Independent Peer Review Panel

IPRP Report No. 5

Slip Rate of the Hosgri Fault: summary of available data and comments on ongoing investigations by PG&E for Diablo Canyon Power Plant seismic hazard studies

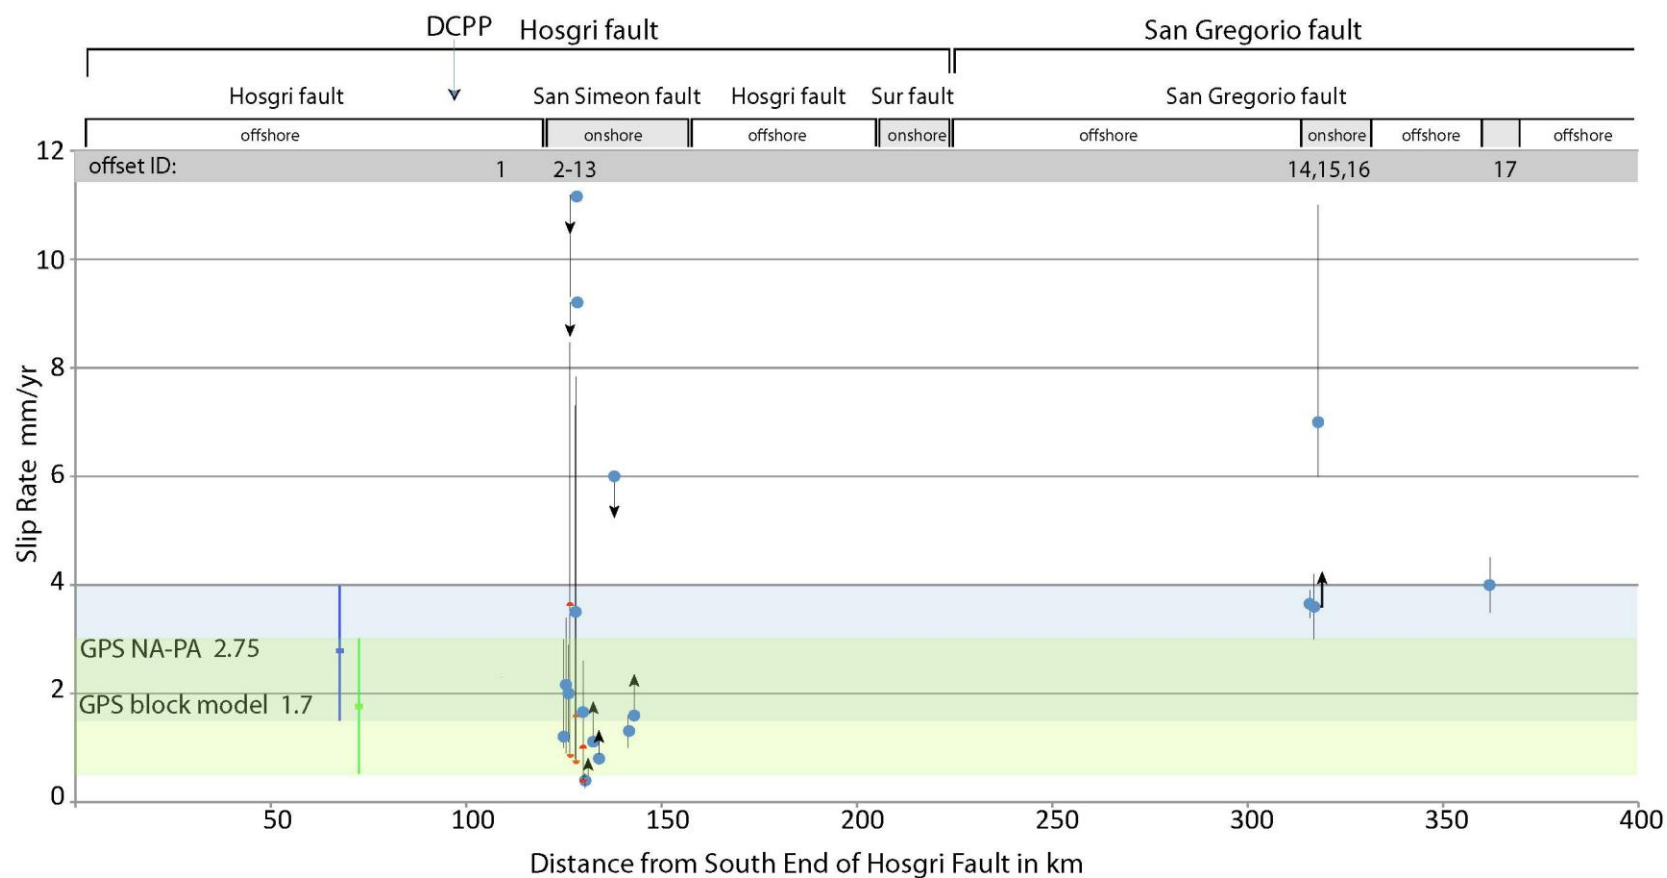
The Airport Creek site fault trench investigation (Hall et al., 1994) at San Simeon yielded three slip rate estimates (2,3,4; Table 1, Fig. 2). These slip rate estimates are for features dating from 5 to 14 ka, and include important assumptions in projection and feature characterization. The apparently offset features consist of a basal terrace gravel, a terrace margin and a vertically separated soil layer. The confidence levels for the central estimates of these slip rates are weak although the range of the estimates (0.9-3.4 mm/yr) appear reasonable. A series of emergent marine terraces (5,6,7; Fig.2) at San Simeon Point ranging in age from 80 ka or 105 ka to 210 ka are offset by the San Simeon fault (Hanson and Lettis, 1994). In order to measure the lateral displacements across the two fault strands comprising the fault zone, sophisticated geometrical reconstructions were used. Additionally, the vertical separations across the fault zone were considered. For each of these marine terraces, two slip rates were calculated, the first based on the lateral displacement and the second inferred from the vertical separation. In general, the more straight forward estimate based on the lateral offsets yielded higher rates: (5) < 11.2 or < 8.6 mm/yr for the San Simeon Terrace (80 or 105 ka), (6) 0.8-7.8 mm/yr for the Tripod Terrace (120 ka), and (7) 0.7 - 2.6 mm/yr for the Oso Terrace (210 ka). In contrast the slip rates inferred from the vertical separations were generally lower (5) 1.6-3.6 or 1.2-2.2 mm/yr, (6) 0.7-1.5mm/yr and (7) 0.4-1.0 mm/yr. This lower set of values based on the vertical separations appears to be more consistent with geodetic rates and was thus preferred by the authors. However, both estimates are permissible because the higher lateral-offset derived rates from the San Simeon terrace (5) represent maximum rates. Hanson and Lettis (1994) comment that measuring the vertical separations does not require the more involved and uncertain projections and reconstructions of the lateral offset measurements, even though the use of slickensides from a distant trench as the parameter to convert vertical into lateral displacement estimates is required.

Along the entire San Simeon fault a series of stream drainages (8,9,10,11,12,13; Table 1, Fig. 2) appear to be offset across the fault zone (Hanson and Lettis, 1994). The main assumptions inherent in these slip rate estimates are that one can confidently correlate drainages across the fault zone and that the apparent deflections are entirely due to fault displacement. Only limiting age control is provided by the drainages being incised into known age surfaces; one does not know how long after formation of the surface this incision occurred. Hence these resulting slip rates are minimum estimates with the exception of (11). The Arroyo de la Cruz Channel offset (11) is reported as a maximum rate of 6mm/yr, because the channel deflection cannot entirely be attributed to fault displacement with confidence. The age estimates for these terraces range from 320 ka to 500 ka. The resulting slip rate minimums range from 0.3 to 1.6 mm/yr. Minimum slip rate estimates are not as valuable in seismic hazard analysis as more precise values, but they do provide constraints to combine with other slip rate estimates.

At the Ano Nuevo headlands two offset features along the San Gregorio fault have been reevaluated by Caskey (2012) using LiDAR as presented by Hanson (2012). These offsets (14,15) consist of an offset terrace riser (83 ka or 105 ka) and the Green Oaks Creek drainage incised into the 83 ka surface. The resulting slip rates estimated by Caskey are 3.4-3.9 mm/yr and 3.0-4.2 mm/yr, respectively. Previous workers (Weber et al., 1995; Clark et al., 1999) calculated higher rates (16), mainly due to additional offset inferred on an eastern strand that Caskey asserts does not exist or is no longer active.

The geodetic constraints add bounds on the Hosgri slip rate as indicated in Figure 2. A wider aerial perspective is provided by assessing the rate in relation to the entire Pacific plate, resulting in a best averaged rate of 2.75 mm/yr (DeMets, 2012). This rate represents the entire offshore slip rate budget west of DCP. Block modeling allows a more fault-specific slip rate determination but is very sensitive to the details of the block boundary geometries and any constraints put on individual boundaries. Because most of the Hosgri fault is offshore, with no direct slip rate determinations to date, this modeling provides an approach to assessing the offshore rate by improving our slip rate estimates on all other faults, most of which are located onshore. Sorlien (2012) presented the possibility that slip may be occurring on faults west of the Hosgri fault. If true, this would decrease the Hosgri slip rate (DeMets, 2012).

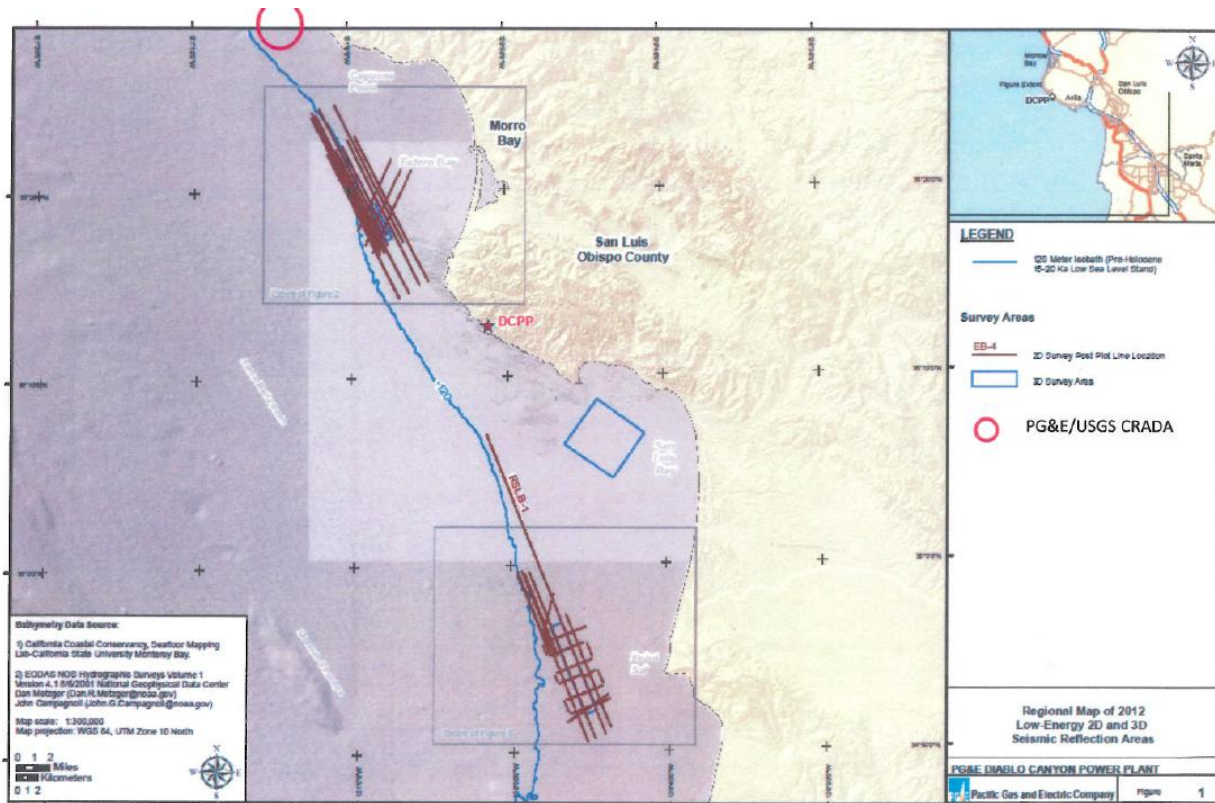
At the February 25 IPRP meeting, PG&E presented ongoing work being undertaken to further characterize the Hosgri slip rate. They defined two areas along the Hosgri fault where they have collected low energy high resolution 2D survey grids (Figure 3). The areas are elongate fault parallel boxes designed to capture geologic structures that cross the fault. The survey box dimensions are approximately 4 x 18 km and 4 x 35 km, for the northern and southern boxes, respectively. The northern survey box extends along the fault from the latitude of Cayucos south, and the southern survey box extends south from Pismo Beach. Apparently the survey box locations were selected based on the perception that they were likely to include offset fault-crossing structures such as buried channels. During the last glacial maximum (LGM) approximately 20 ka ago, the sea-level was 130 m below current sea level. Both survey boxes are located at depths shallower than the LGM sea-level and hence may contain channels eroded during the LGM. Similar sea levels occurred during marine stages 5e approximately 130ka ago, 7a, and 9c. Given the data we have reviewed, it is not clear how comprehensive this selection of focused survey targets has been. However, the value of slip rate determinations in these areas is very high.

The northern survey area includes considerable fault complexity as it extends from north of the Los Osos fault intersection to south of the Shoreline fault intersection. Within the survey box the water depth along the Hosgri fault is approximately 80m. The northern end of the Shoreline fault trace is based on a projection of a modeled fault plane using micro earthquake locations at depths of 5-12 km. Recent mapping by PG&E has identified a fault slightly northeast of the originally mapped northern Shoreline fault, which they named the Point Buchon fault. This fault and its associated traces extend to within 500m of the Hosgri fault trace.

The southern box is located between the Pecho and Casmalia fault intersection projections. Within the survey box the water depth along the Hosgri fault is approximately 110m to 120m. The Casmalia fault bends northward as it approaches the Hosgri fault from the east, and trends parallel to it at a distance of approximately 2 km. The northern end of the Casmalia fault zone terminates in shorter discontinuous faults. The Pecho fault, possibly an extension of the onshore Oceano fault, and perhaps bounding the southern end of the Shoreline fault, is much less expressed compared to the Casmalia fault and has been mapped as transitioning into a series of folds which approach the Hosgri fault. These fold structures bend northward and become parallel to the Hosgri fault.
